Since April 1972 a modified windshield header molding and modified guide bearings have been installed in these vehicles.

### Production Breakpoint

R 68/7611

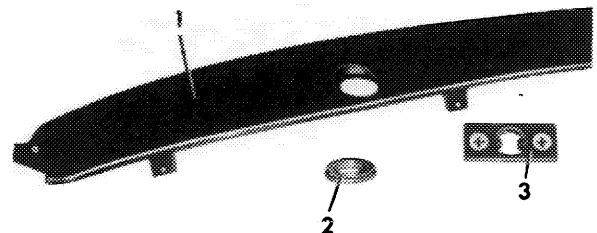
When installing the modified windshield header molding in vehicles with lower chassis end numbers, the two guide bearings and the two washers must also be replaced.

- 1 Unscrew windshield header molding (1) from front panel frame.
- 2 Remove both guide bearings.
